UNITED STATES OF AMERICA
NUCLEAR REGULATORY COMMISSION

ARMED FORCES RADIobiology
RESEARCH INSTITUTE
(TRIGA-Type Research Reactor)

Docket No. 50-120

LICENSEE'S ANSWERS TO
INTERVENOR'S INTERROGATORIES

Figure 1. Standard AFRRRI TRIGA Fuel Element

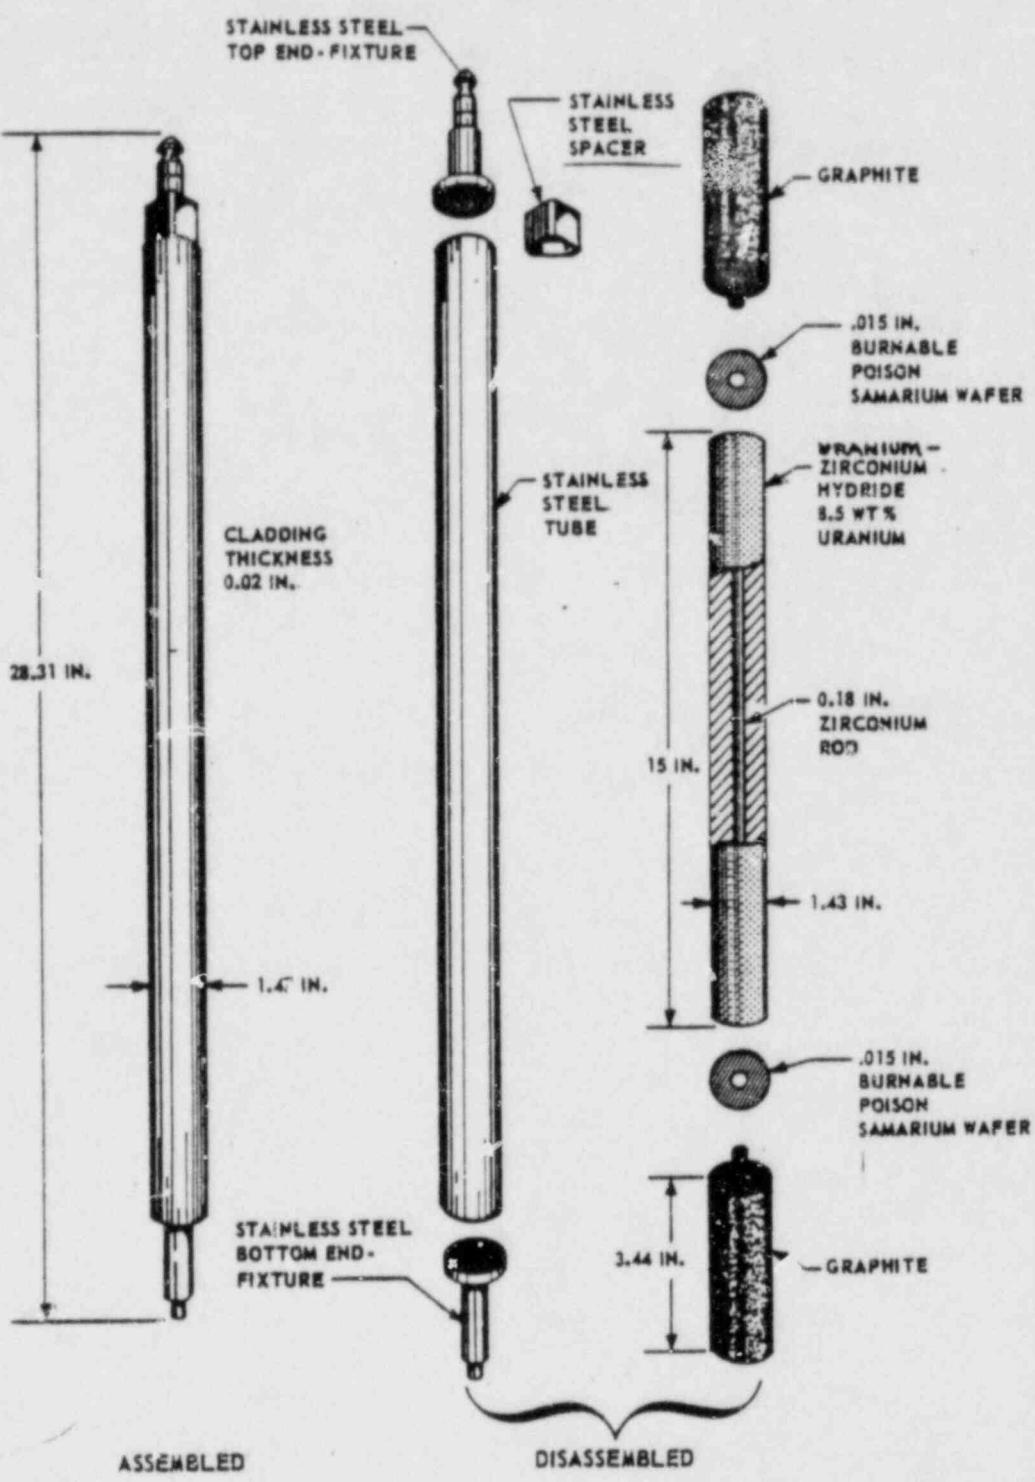
3. Fuel elements used in the AFRRRI reactor are standard stainless-steel clad TRIGA elements containing U-ZrH_{1.7} with 8.5 weight percent uranium at a nominal U²³⁵ enrichment of 20 percent (See Figure 1). Each fuel element contains a nominal maximum 38 grams of U²³⁵.

Fig. 2. Minimum critical mass as a function of U^{235} enrichment in hydrogen-moderated systems

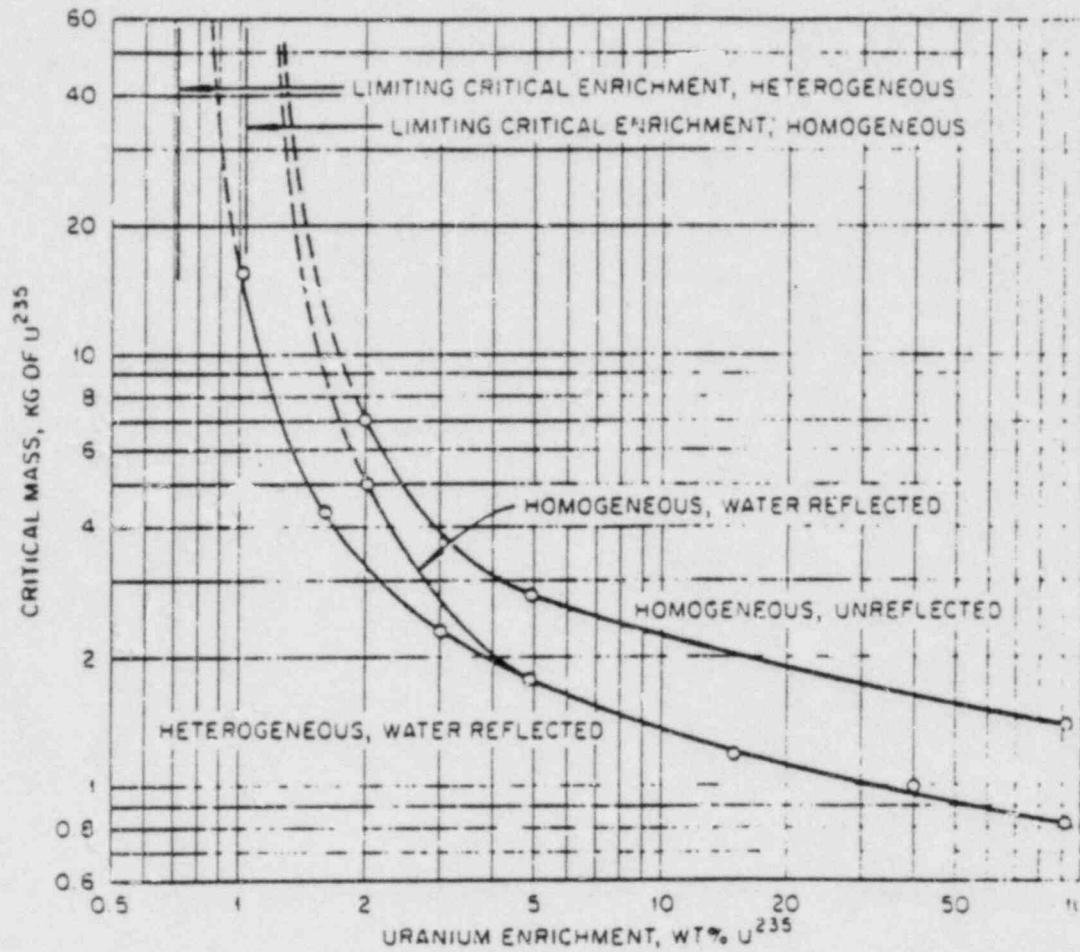
4. Figure 2, reproduced from TID-7028⁽¹⁾, is based on experimental and analytical data and indicates that the minimum critical mass, $m_{crit.}$, for a heterogeneous, 20% enriched, fully water reflected U²³⁵ system in its most reactive configuration, * is 1.1 kg of U²³⁵. Since our assumed twelve element configuration contains a total of (12 fuel elements) X (38 grams U²³⁵/fuel element) = 456 grams U²³⁵, it would have a mass fraction critical, m/m_{crit.}, less than or equal to 0.456 kg U²³⁵/1.1 kg U²³⁵ or 0.415.

Based on the minimum critical mass, $m_{crit.}$, value of 1.1 kg U²³⁵ obtained from Figure 2, and a U²³⁵ fuel loading per element of 38 gm U²³⁵, a minimum of 29 AFRRRI TRIGA fuel elements arranged in an optimum neutronic configuration would be required for a criticality excursion ($\approx \$.09$) to occur.
